FOR PERCOLATION TESTING AND SITE EVALUATION

SUBDIVISION/PROPERTY NAME Gatewood Property
PROPERTY ADDRESS Brighton Dam Road Clarksville MD 21029 TOWN ZIP PROPOSED LOT
TAX ACCOUNT #05-350-778 TAX MAP 34 GRID 13 PARCEL 232 LOT NO SIZE (ACRES) 1.00 AC
ZONING CATEGORY PR-DED TIER 4
PROPERTY OWNER(S) Shawn Gatewood
DAYTIME PHONE CELL EMAIL
MAILING ADDRESS 1706 Woodman Ave Silver Spring MD 20902 STREET CITY, STATE ZIP
APPLICANT Linda Alexander Relationship to owner: Engineer
DAYTIME PHONE 443-375-9903 CELL EMAIL lalexander @ clsimail.com
MAILING ADDRESS 439 E. Main Street; Westminster, MD 21157 STREET CITY, STATE ZIP
I HEREBY APPLY FOR THE NECESSARY TESTING/EVALUATION PRIOR TO ISSUANCE OF SEWAGE DISPOSAL SYSTEM PERMIT(S):
PROPERTY:          SUBDIVISION:       NUMBER OF LOTS INCLUDING RESIDUE:         SUBDIVISION CLASSIFICATION (PER DEPT. OF PLANNING AND ZONING)       MAJOR         CONSTRUCT NEW OSDS ON UNDEVELOPED LOT         REPAIR OR REPLACE FAILING OSDS         UPGRADE EXISTING OSDS         BUILDING:         RESIDENTIAL WITH         EXISTING OR PROPOSED BEDROOMS IN THE COMPLETED STRUCTURE         COMMERCIAL (PROVIDE DETAIL OF TYPE OF USE AND NUMBERS OF EMPLOYEES/CUSTOMERS ON ACCOMPANY

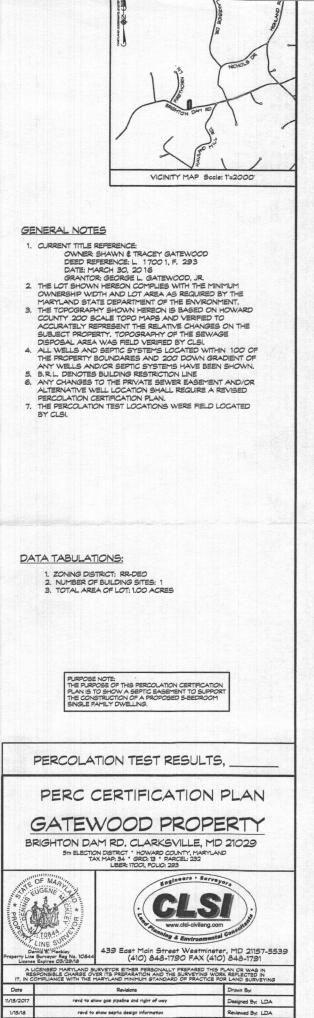
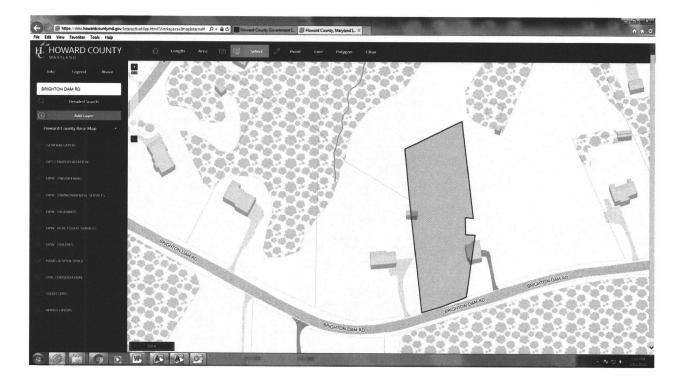
- The SDA created cannot be used because we don't have percolation data to support the bottom portion of this area between holes 1 and 4. The design of the SDA must be revised and may extend out from the percolation holes 20-30 feet. I have attached an example of what your SDA may look like. With this revision we must revised the trenches to accommodate this new design.
- Show the exact house site or use the minimum required 55 X 70 for the dimension of the house.
- The existing well must be labeled "To be Abandoned"
- The existing septic system must be labeled "To Be Abandoned"
- A note must be added to the general notes stating: All wells must be drilled prior to the signing of the plat or the release of any building permits.

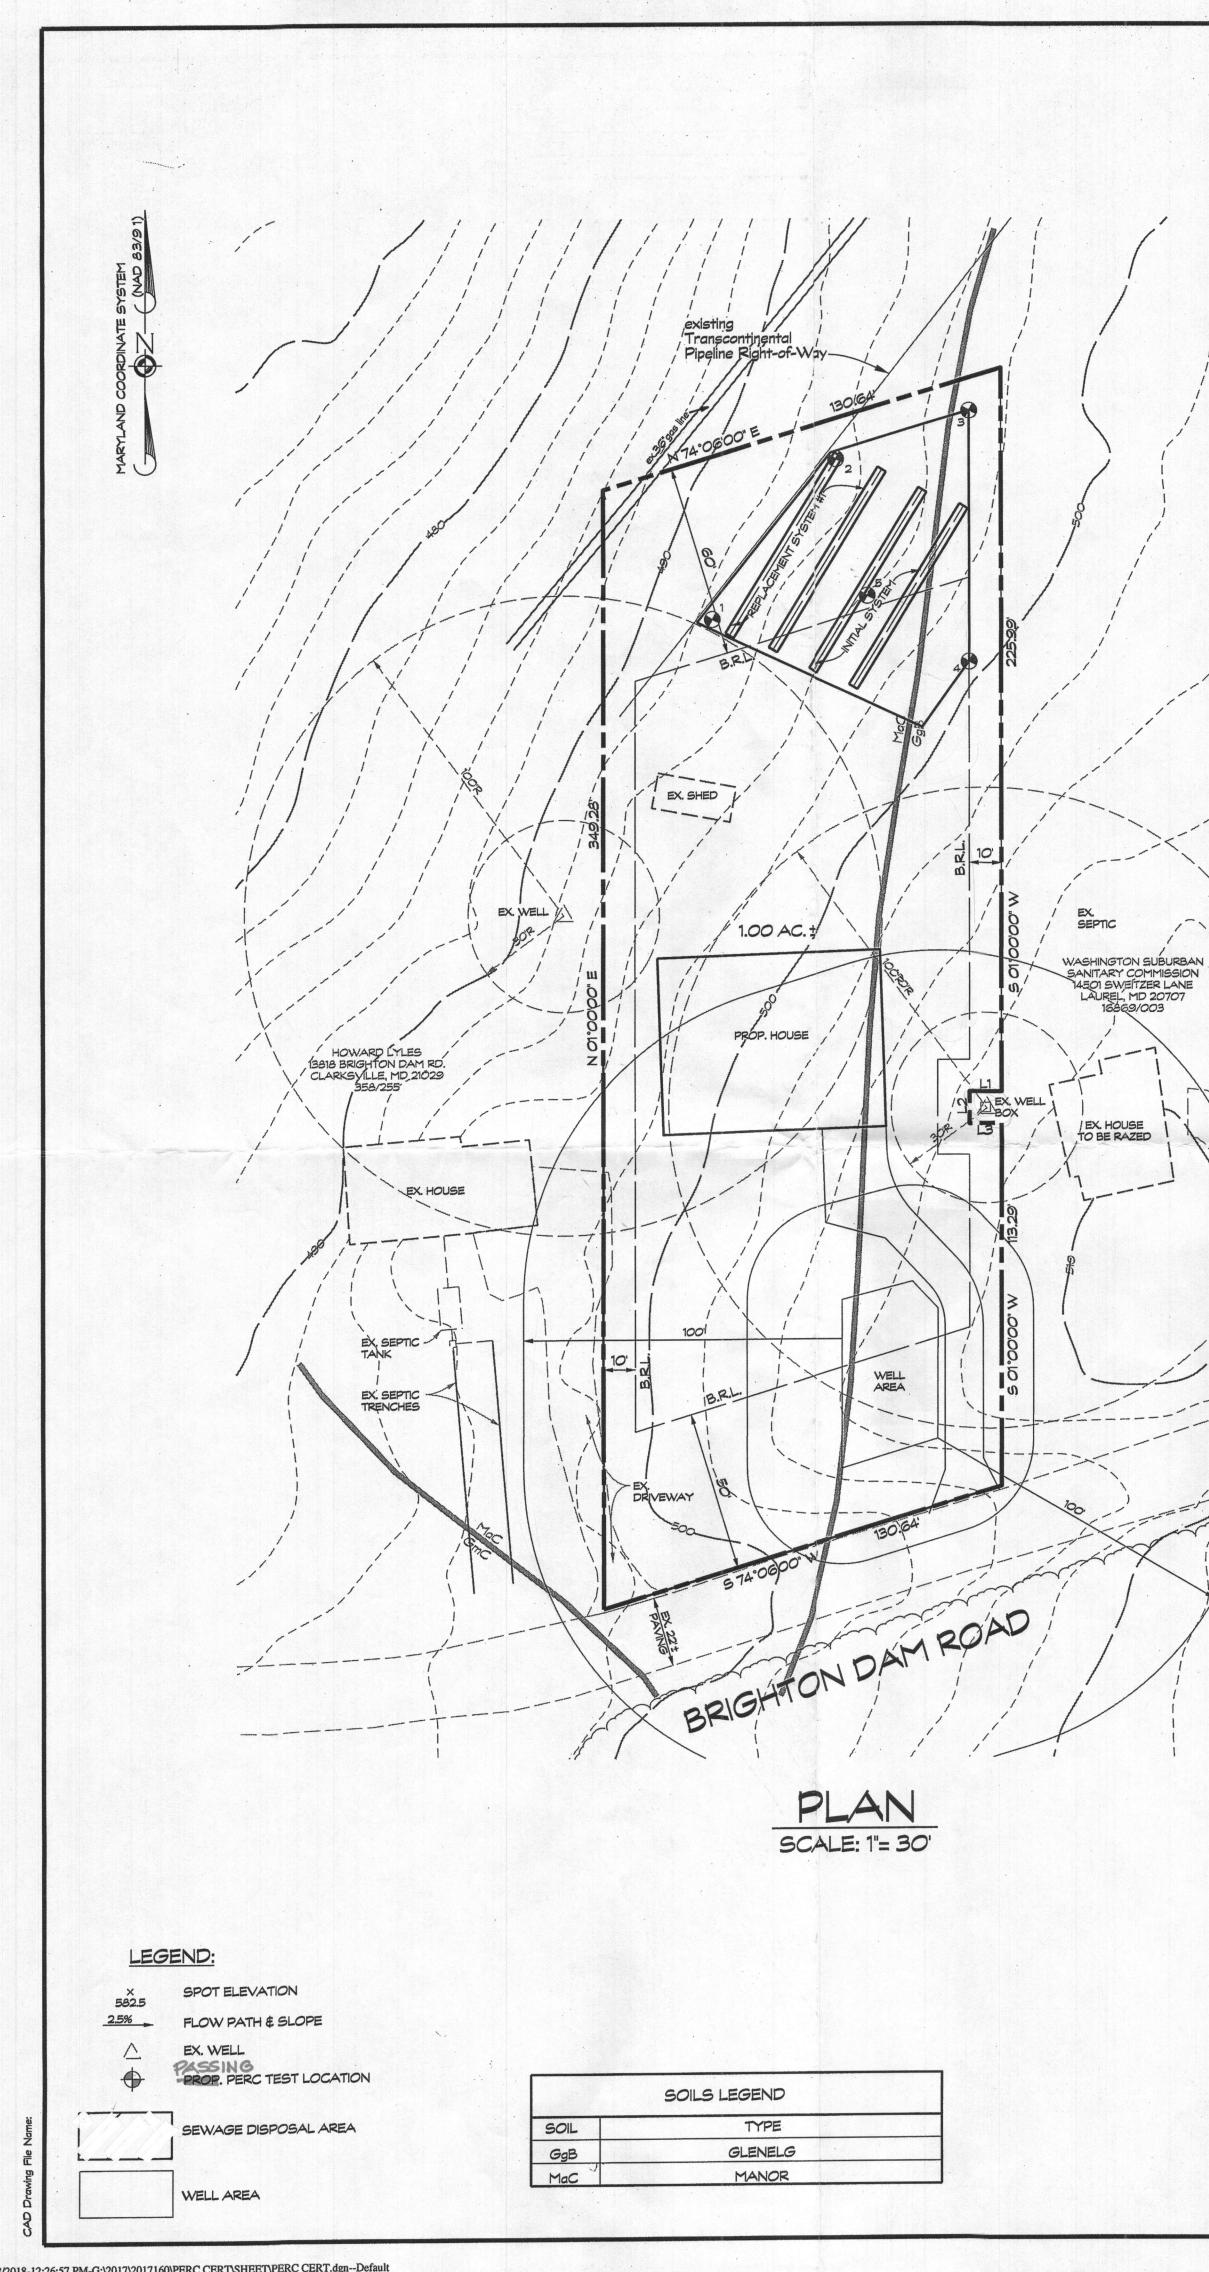
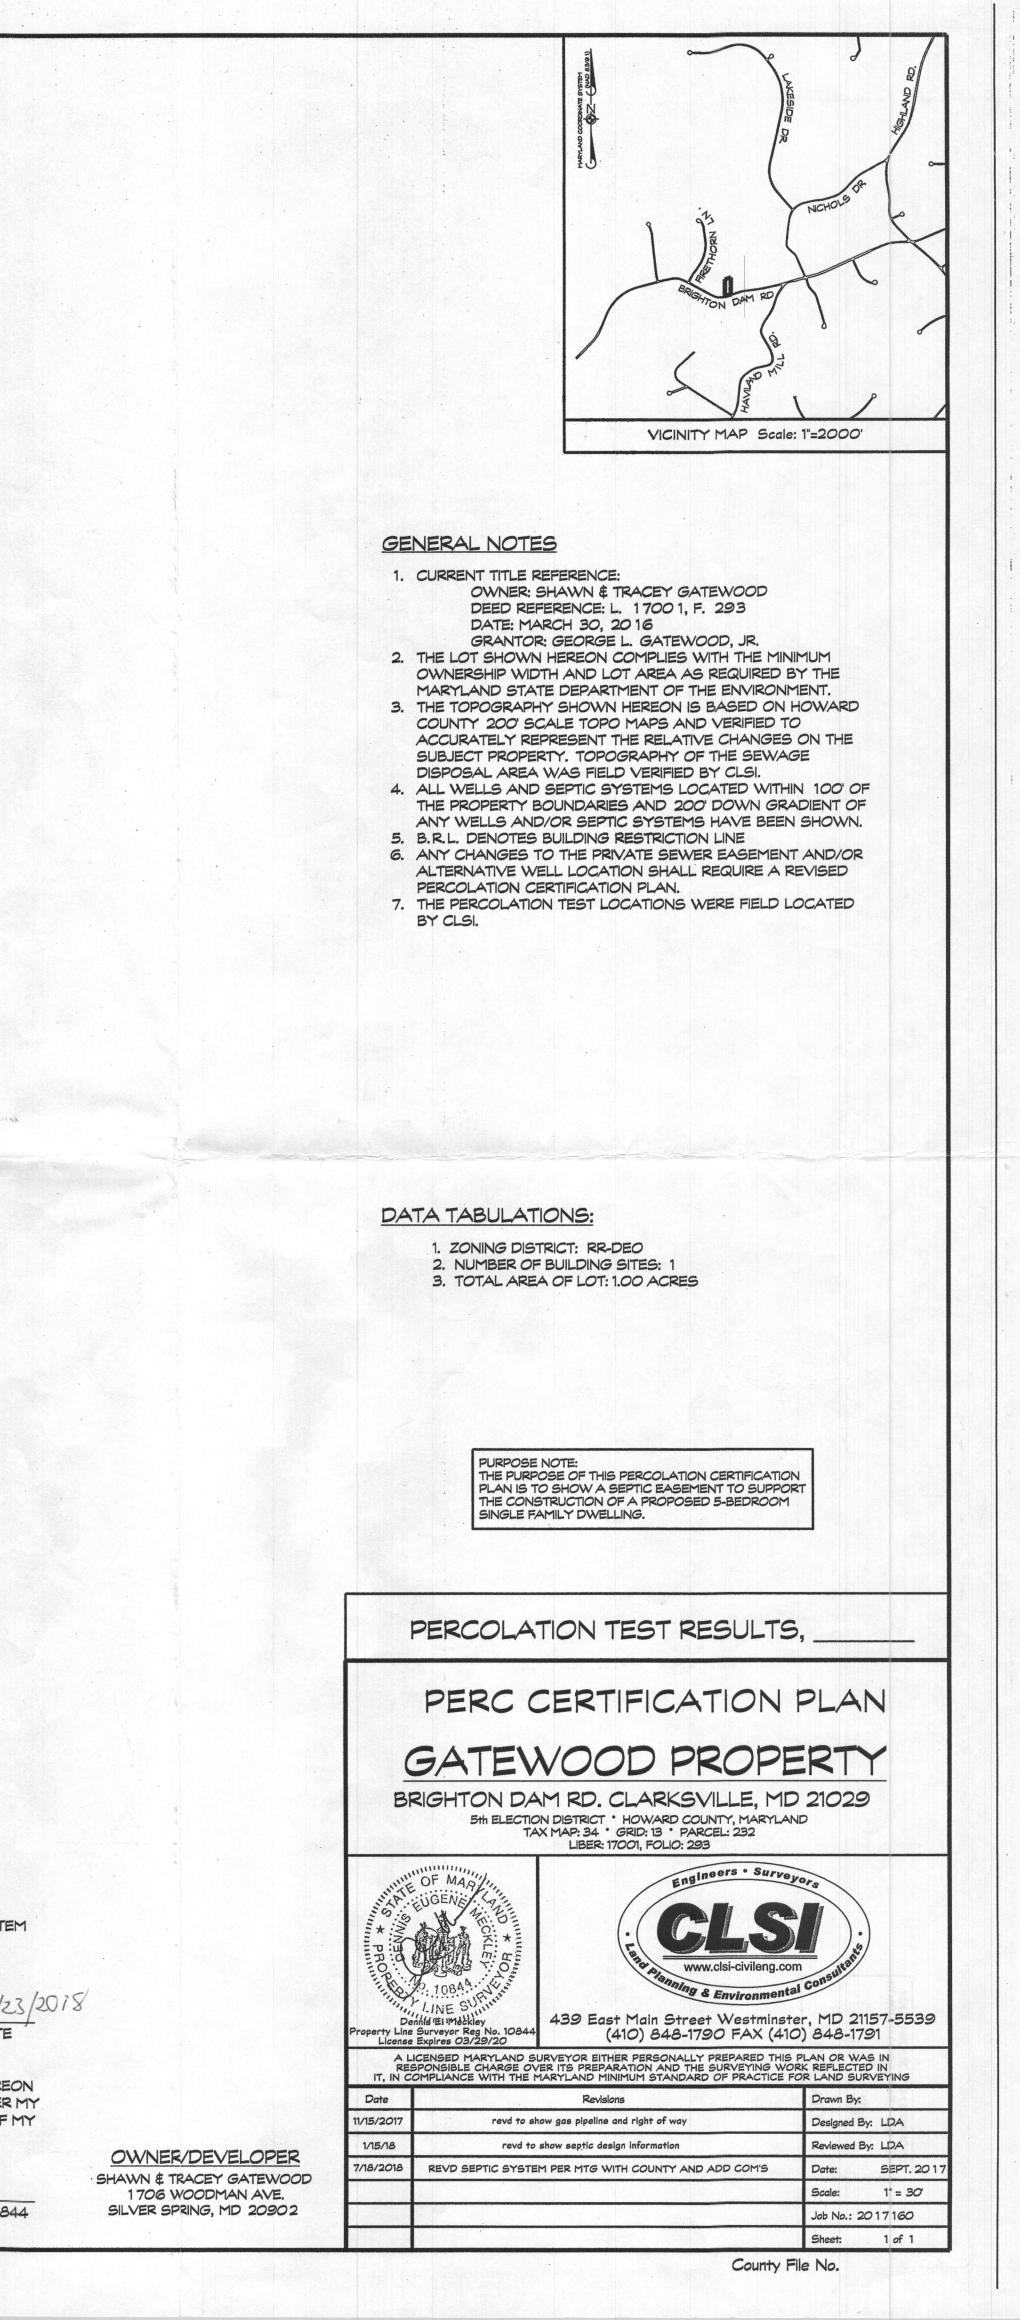
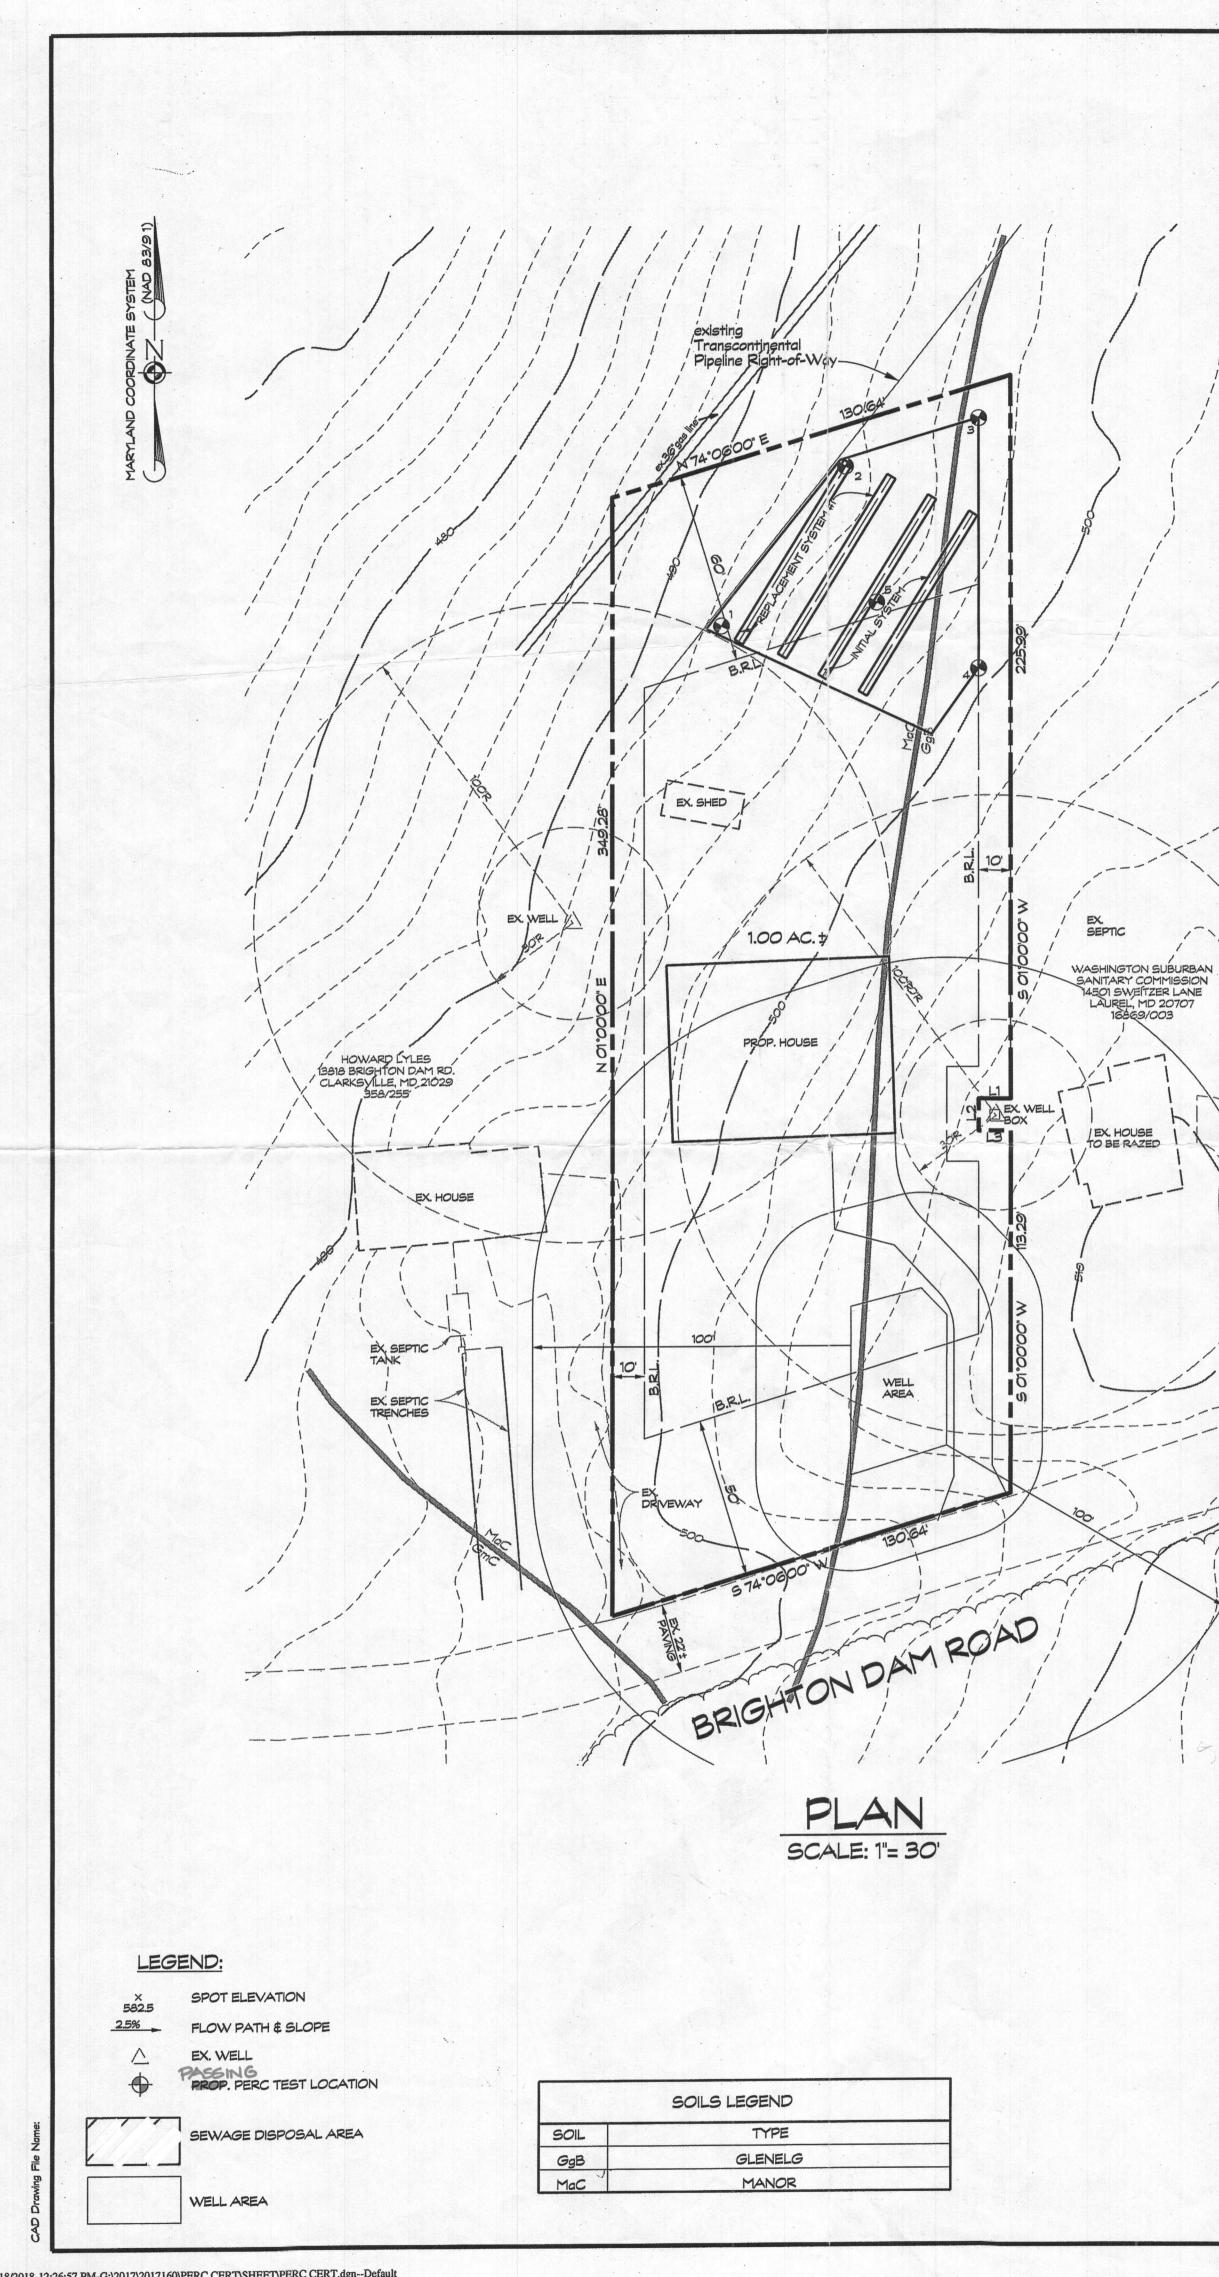
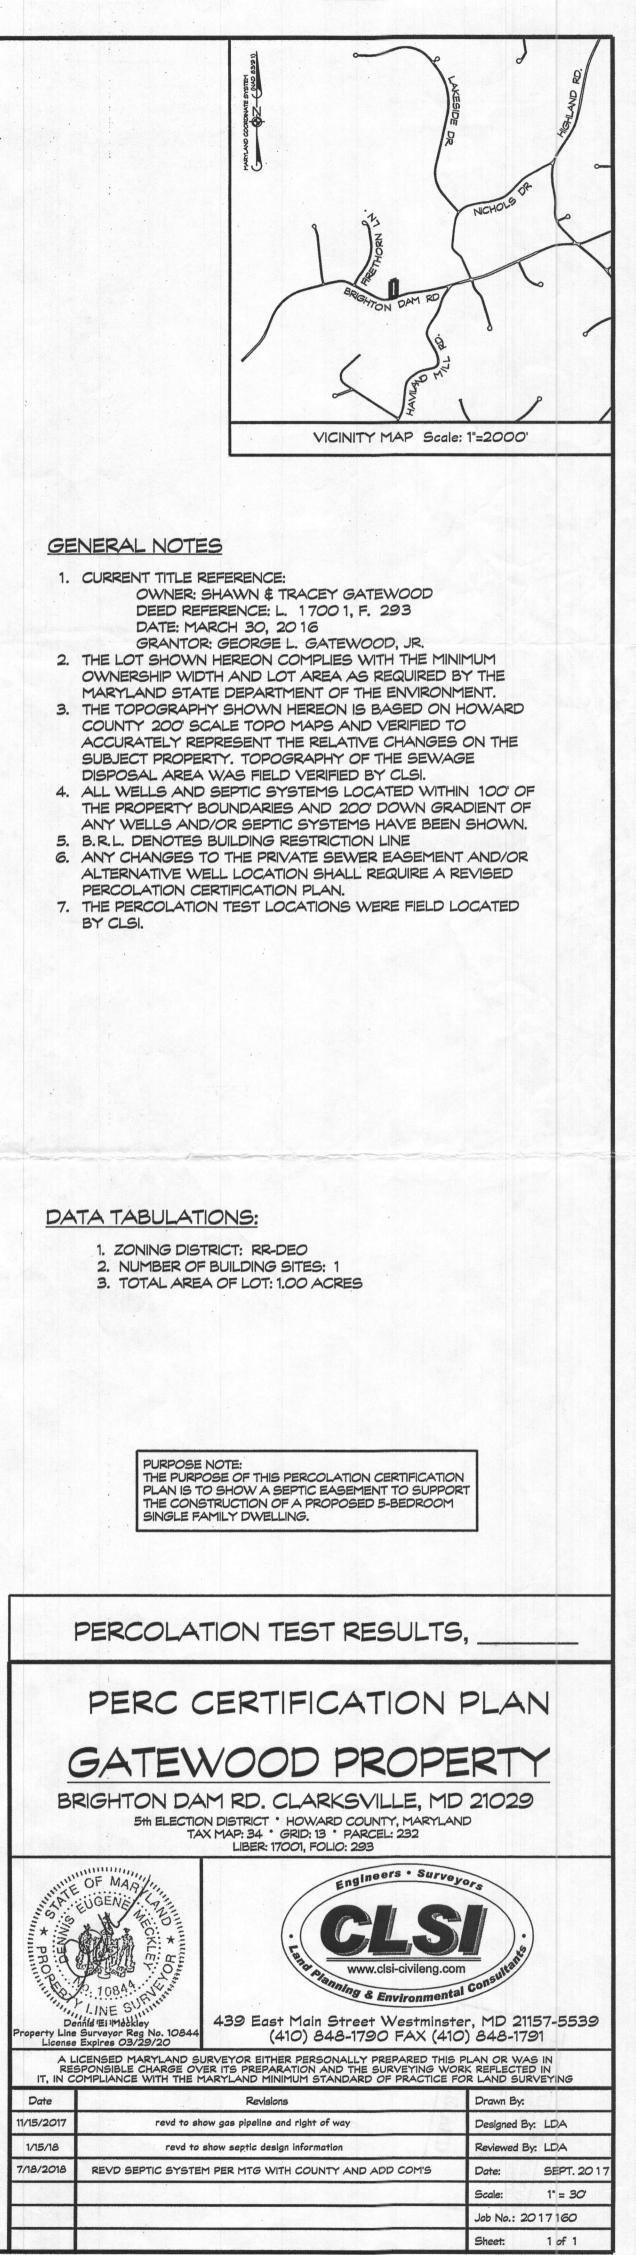
- 1.) The revised perc cert plan shows a sewage disposal area of 5,856 sq. ft. but note #7 references an area of 10,000 sq. ft. Note #7 should read; *This area designates a private sewage area as required by the Maryland Department of the Environment for individual sewage disposal. For lots created prior to March of 1972 it provides at least enough area to accommodate an initial and two replacement septic systems as required by the Howard County Health Department. Improvements of any nature in this area are restricted until public sewerage is available. This area shall become null and void upon connection to a public sewerage system. The county Health Officer shall have the authority to grant adjustments to the private sewage area. Recordation of a modified sewage area shall not be necessary."*

- 2.) Match existing well symbol on plan with the legend symbol.
- 3.) Change wording in legend symbol to "Passed Perc Test Location".
- 4.) Add a purpose statement to the plan. Refer to the previously approved perc cert plan.

- 5.) Make well box 30 feet from proposed porch by revising shape of well box or shifting house location.
- 6.) Add note; The sewage disposal area, the property lines and gas pipe line right of way must be staked by a licensed surveyor prior to the septic layout inspection.
